**TOWN OF MOUNTAIN VILLAGE  
REGULAR DESIGN REVIEW BOARD MEETING  
AGENDA**

**THURSDAY SEPTEMBER 3, 2020 10:00 AM**

**TO:** Mountain Village Design Review Board  
**FROM:** John Miller, Senior Planner  
**FOR:** Design Review Board Public Hearing; September 3, 2020  
**DATE:** July 23, 2020, *Updated August 21, 2020*  
**RE:** Staff Memo – Initial Architecture and Site Review (IASR) Lot 630

**LANDSCAPE IRRIGATION PLAN**

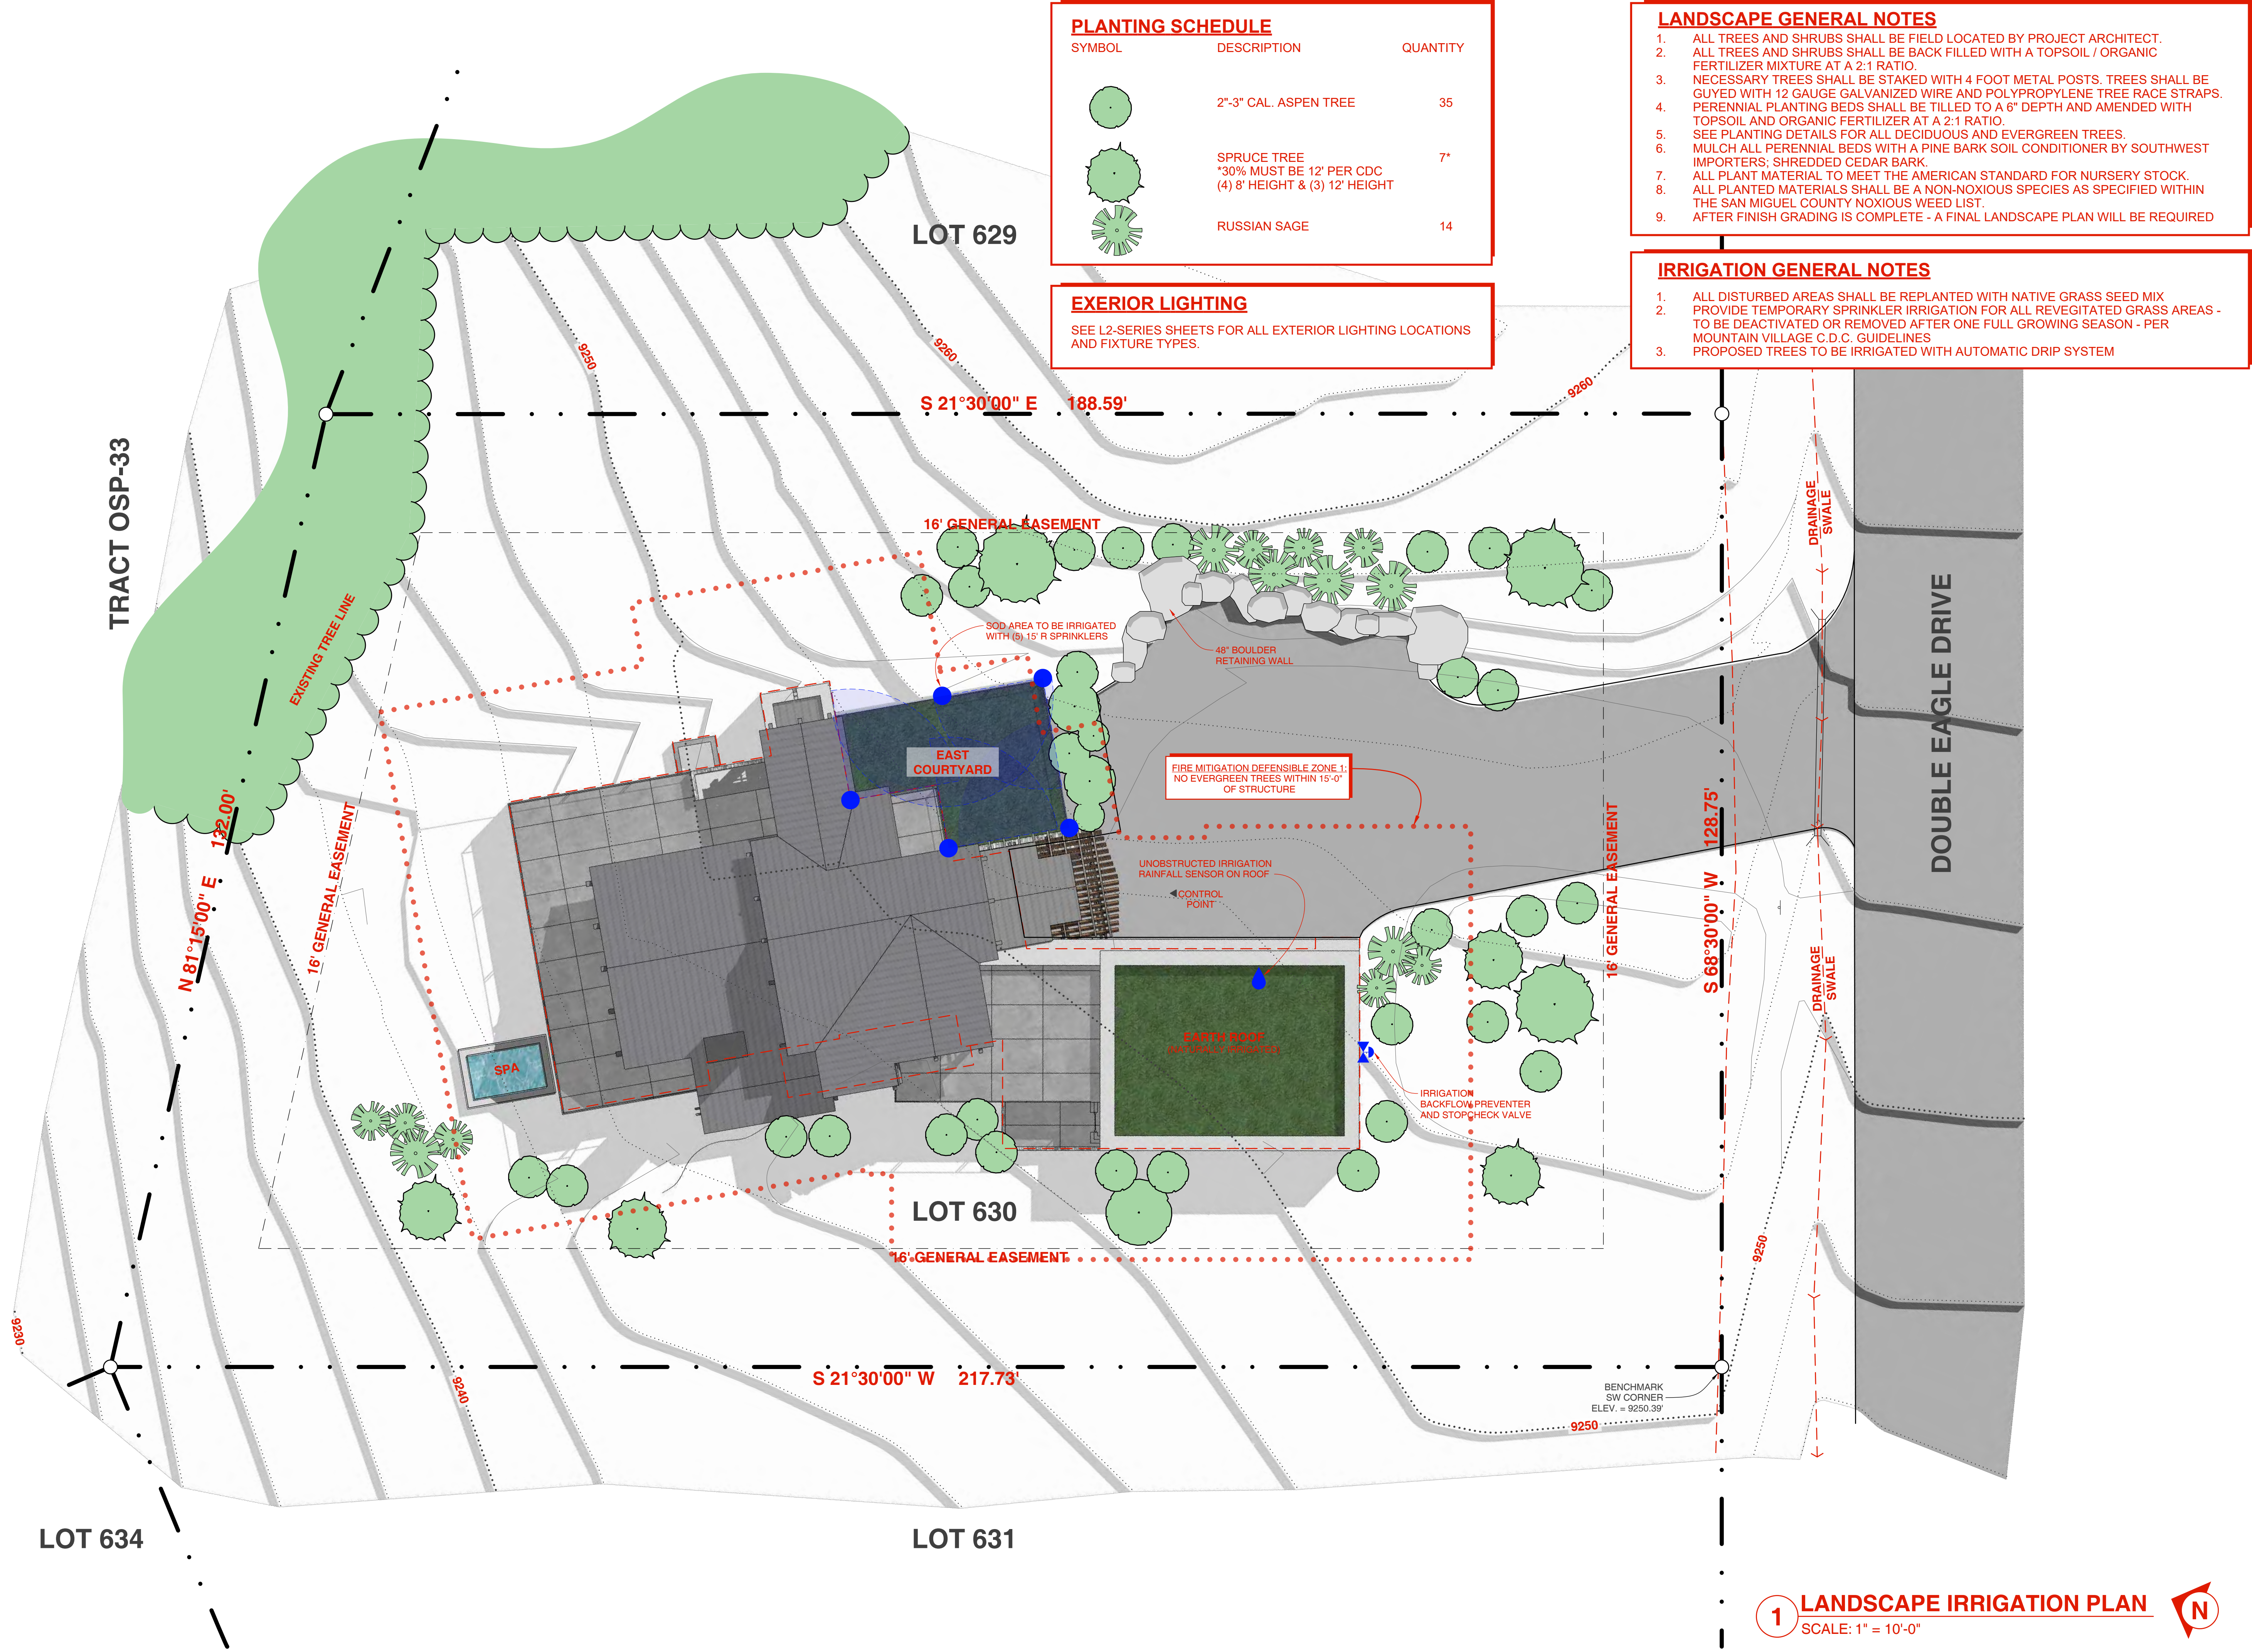
*The applicant has revised the preliminary landscaping plan based on feedback from the July hearing, to include irrigation notes, revegetation notes, and other general requirements. The applicant has included additional Russian sage plantings, but staff would still like to see some additional tree diversity on the lot – whereas additional tree species are incorporated in the place of some aspen and spruce.*

- 2) Prior to the submittal for a Final Architectural Review, the applicant shall provide an updated landscaping plan providing additional variation in the proposed tree species.

## ROOF HEIGHT CALCS.

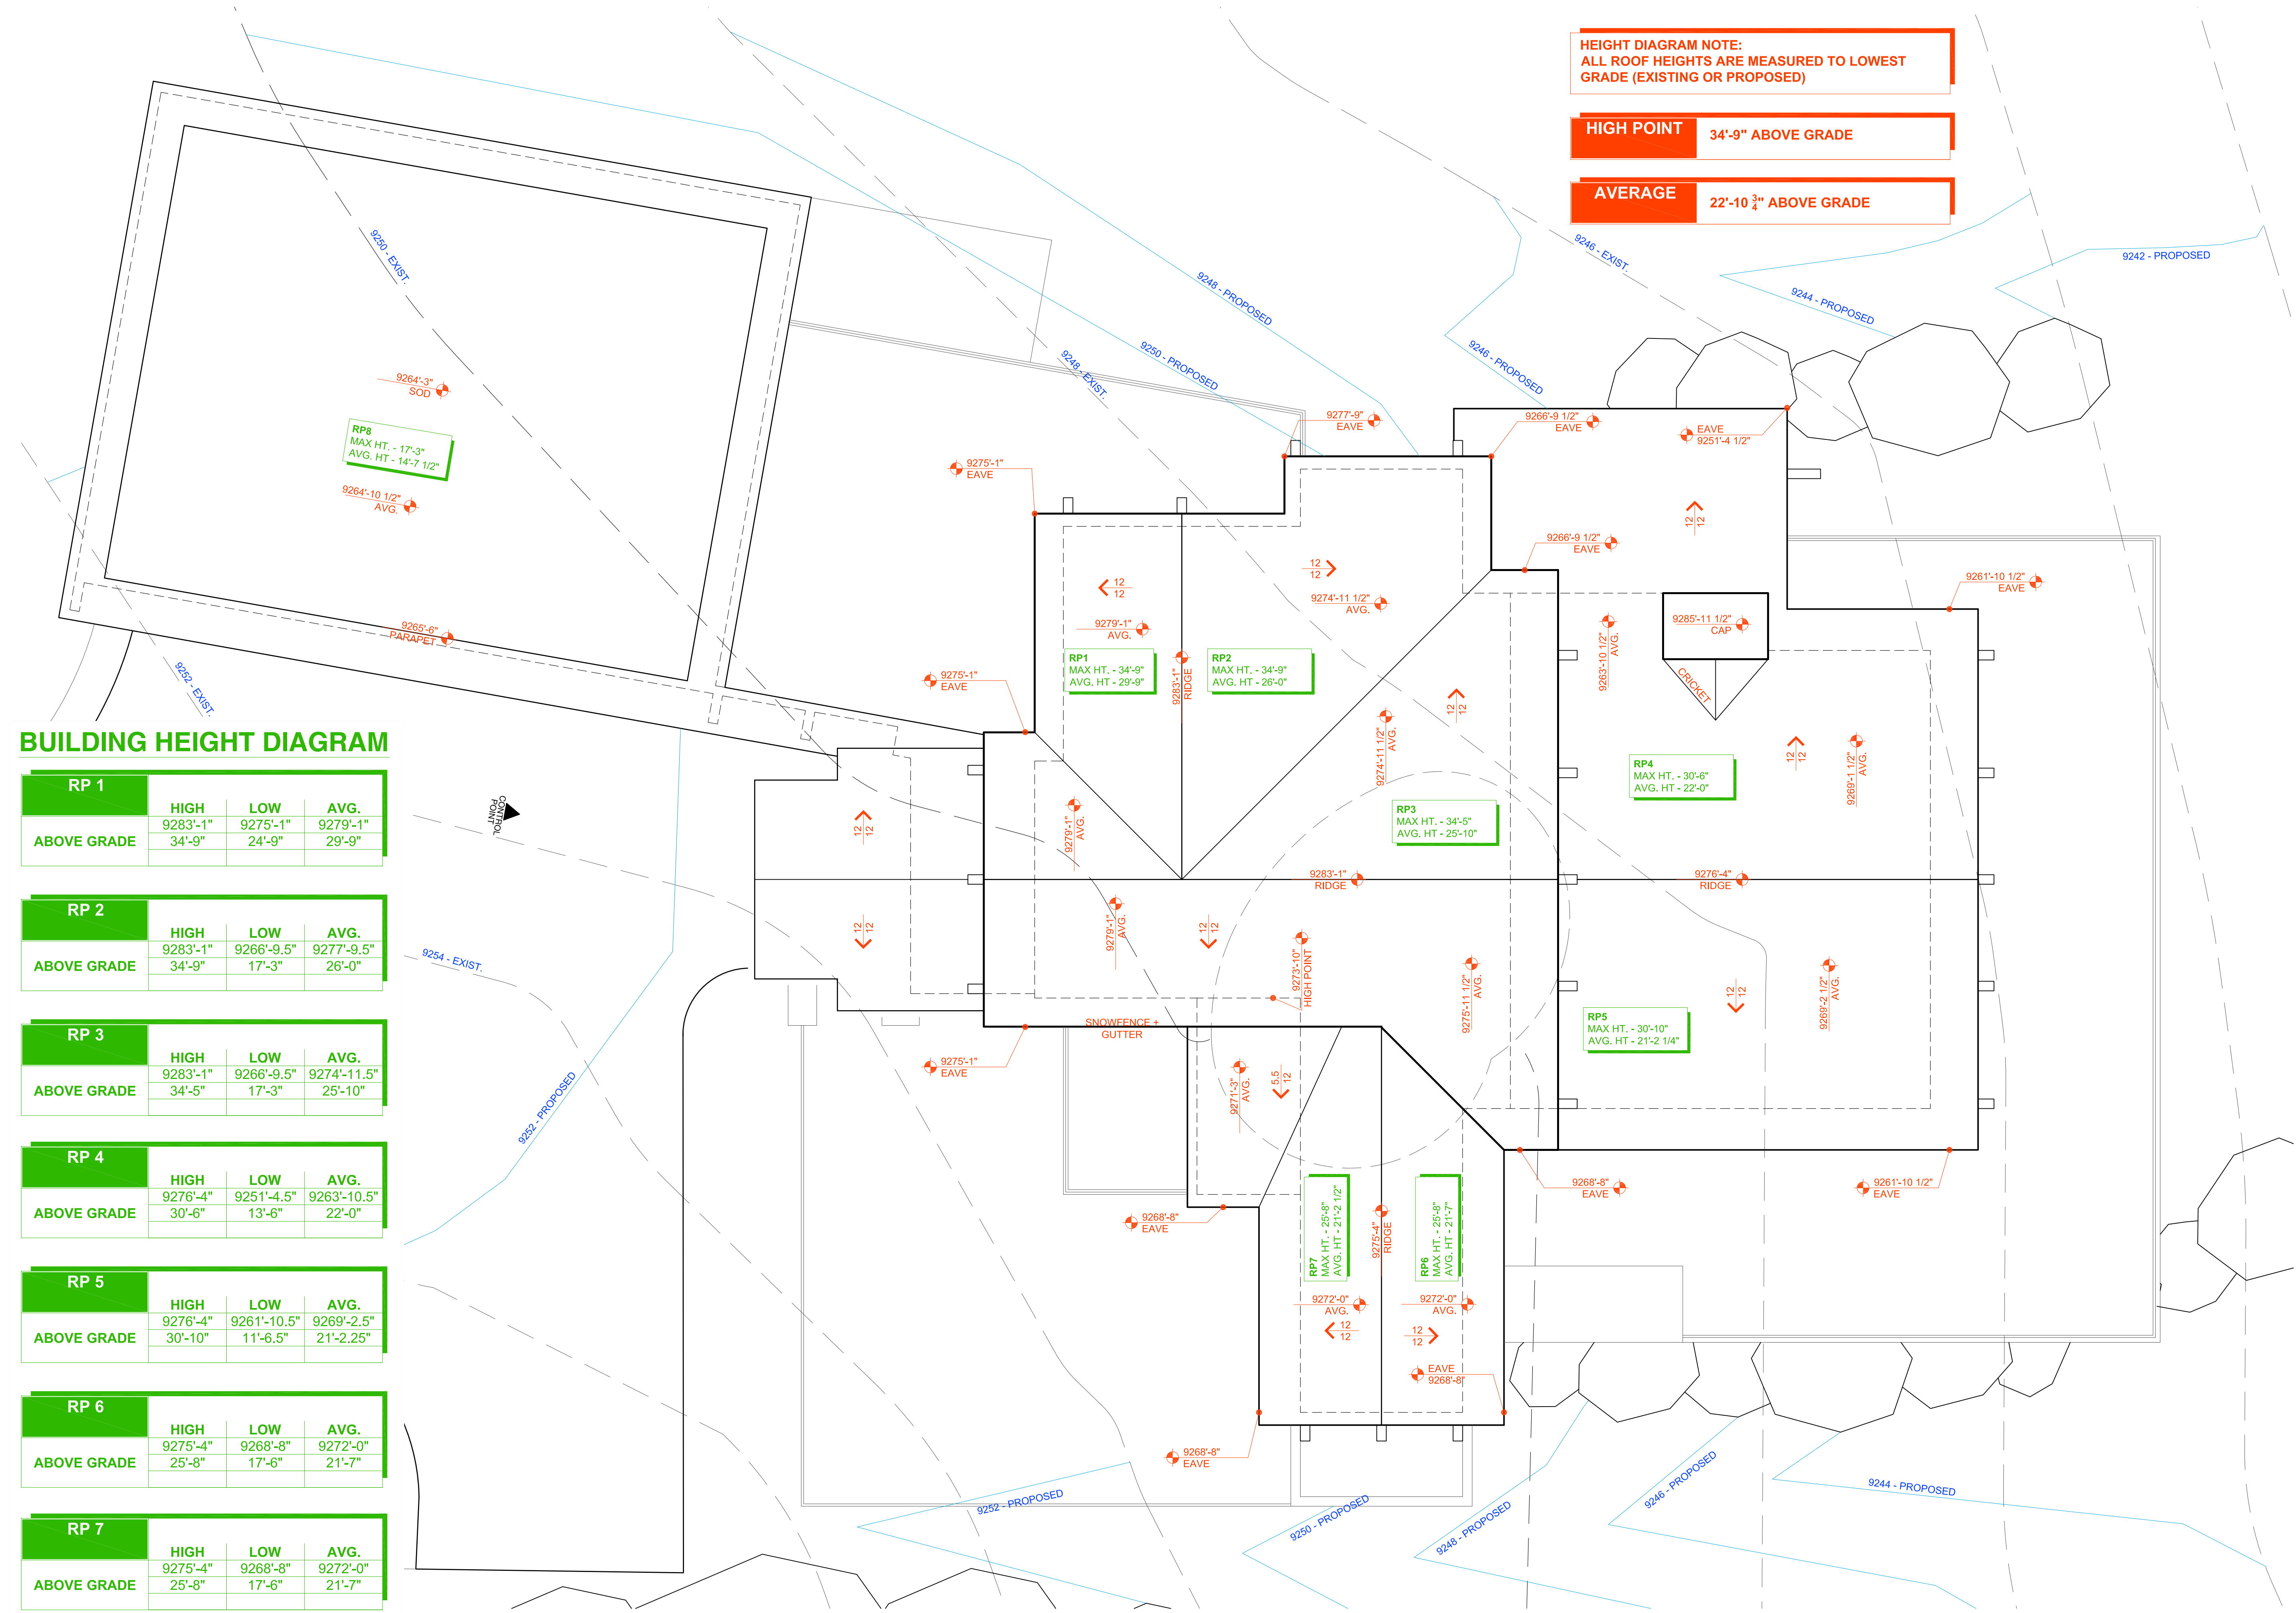
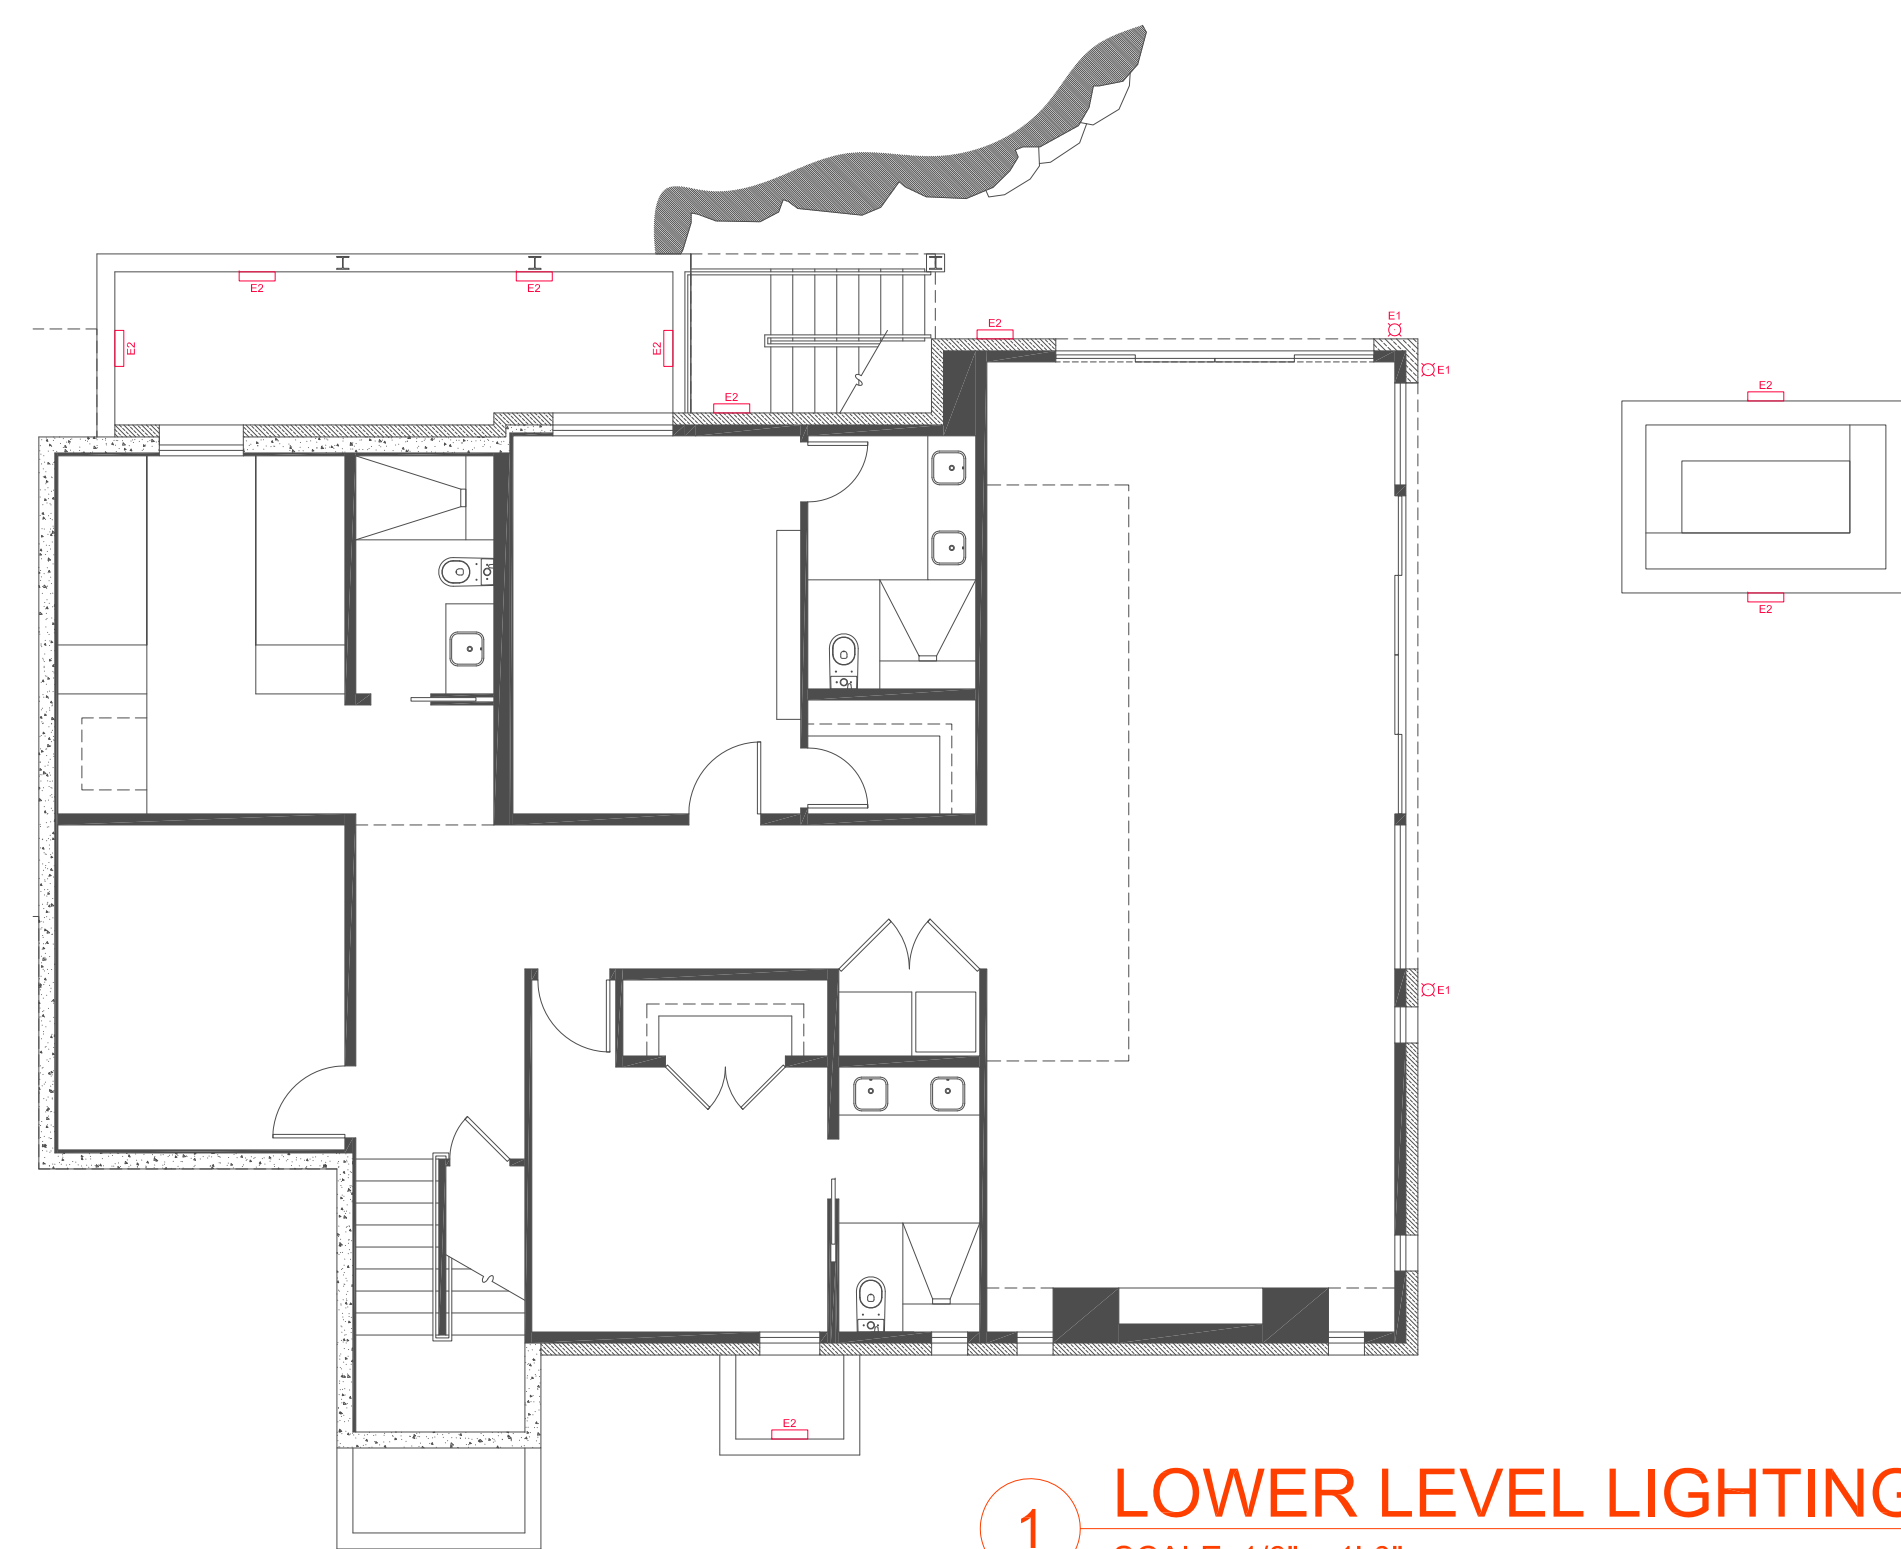
*Staff: Since the July hearing, the applicant has revised both the Maximum Building Height and the Average Building Height Analysis' to address staff concerns detailed in the July memo. Based on the elevations provided, the maximum height for the structure is 34' – 9" from the highest ridge to the most restrictive grade. The applicant has provided a parallel plane analysis demonstrating that no portion of the home penetrates the 40-foot parallel slope height allowance. The average height calculations have been revised since July based on staff's comments, and the analysis appears to now be compliant with the CDC requirements for both maximum height and maximum average height.*

- 1) Prior to the submittal for a Final Architectural Review, the applicant shall revise the Building Height Diagram to demonstrate both Maximum Height and Average Maximum Height per the notes provided within this staff memo.
